Sirajgonj Fashions Limited (UNIT 02)

28th August 2017

Observations

Ground floor plan

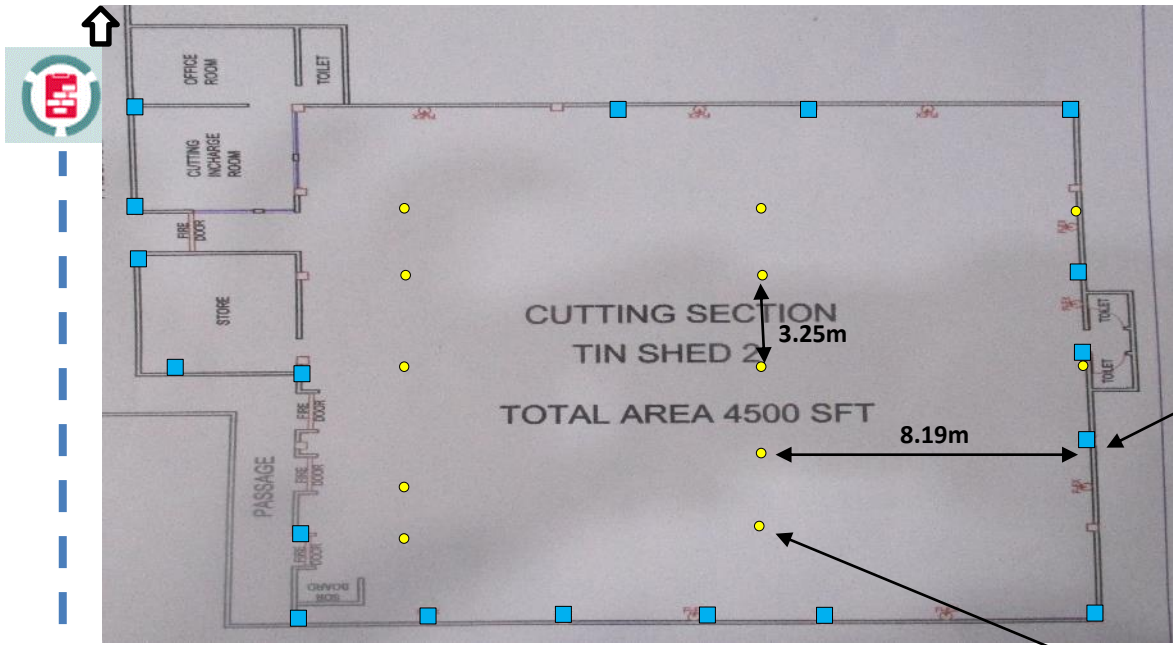
The lightweight shed was supported by truss and steel pipes. But details of framing and connection was not available in provided drawing.

The connections of the truss & steel pipe are apparently non-engineered and the foundation type of the columns are not clear. Factory engineer to be checked the stability of the structures against uplift forces arise from lateral loading.

Factory engineer to survey the building and prepare the as-built documentations.
Stability of lightweight steel shed to be checked for uplift forces.
